City of Carlisle, Iowa
Planning and Zoning Commission
Regular Meeting
March 20, 2023

RE: Carlisle High School Maintenance Facility – Site Plan Review
Project No. 7023.066
City of Carlisle, Iowa (City)

Comment Response Letter

Carlisle High School Maintenance Facility Site Plan

DEMOLITION PLAN

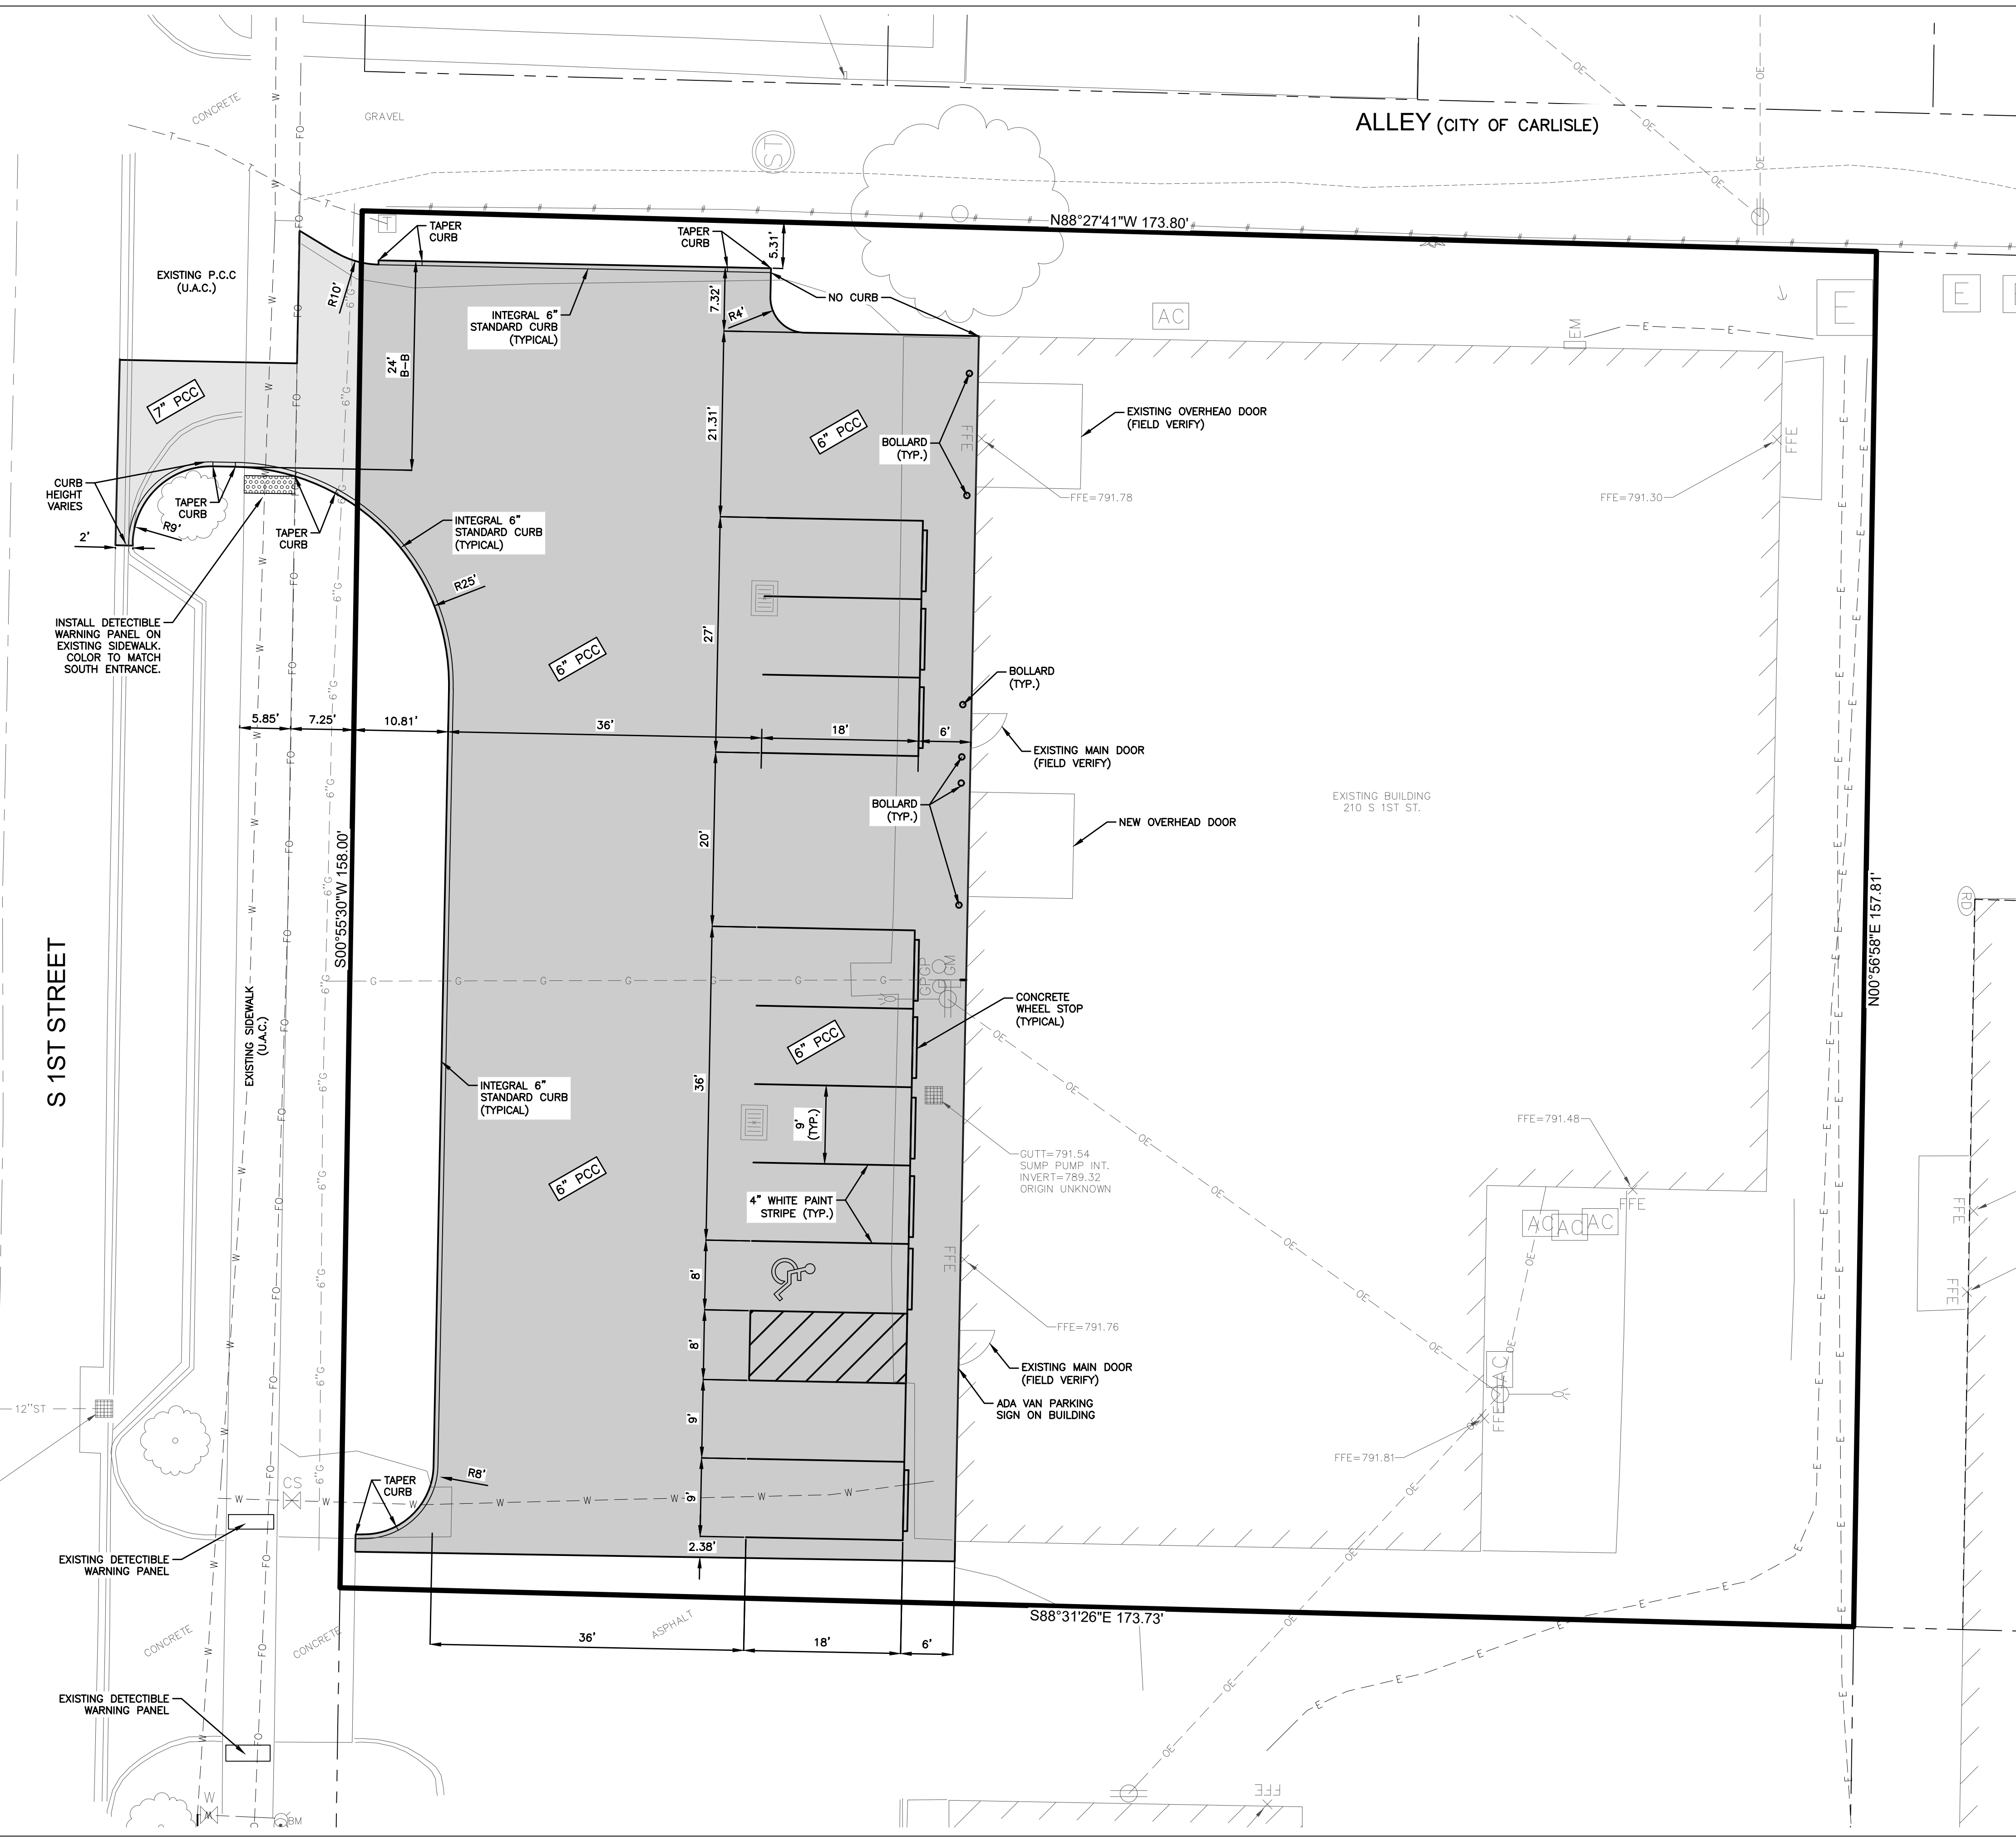
1. Please show the existing grade contours on this sheet to verify where the existing parking lot drains to.
 - **Existing contours have been shown.**
